## **STAFF REPORT AND RECOMMENDATION TO THE LANDMARKS COMMISSION**

**CASE FILE:** LU 16-207720 HRM AD  
PC # 16-134597  
*Multnomah County Central Courthouse Project*

1  
A.3 Elevation - South @ Jefferson St

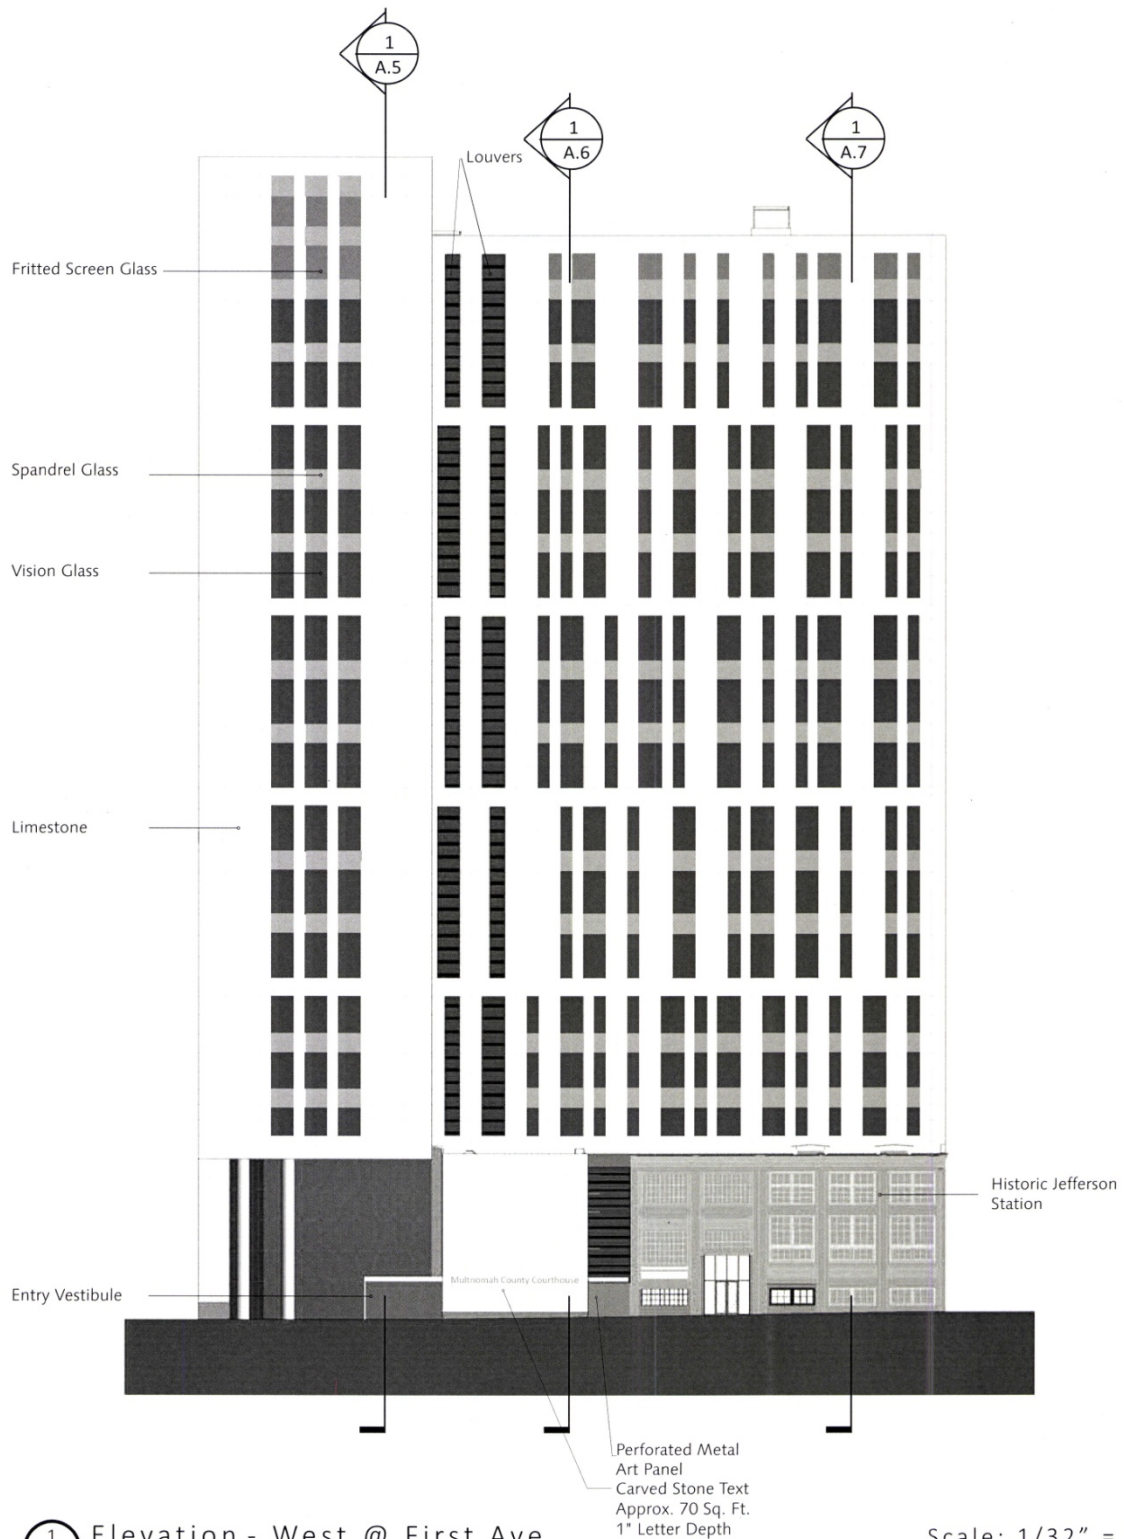
At the most recent DAR it was noted that on the south (Jefferson) façade there was little response to the proportions and rhythm of the ground floor openings of the landmark on the addition's ground level. The scale and height of the sally port opening appears to be the primary contributor. The width of the opening appears to have increased since the DAR to allow the decorative art panel doors to slide back and remain visible during the day when the secondary gate behind is in operation. Ensuring the artistic panel remained a primary element of the façade at all times was encouraged by the Commission. Therefore, these two items need to be further discussed to find a way to achieve both goals or understand if one take precedent over the other.
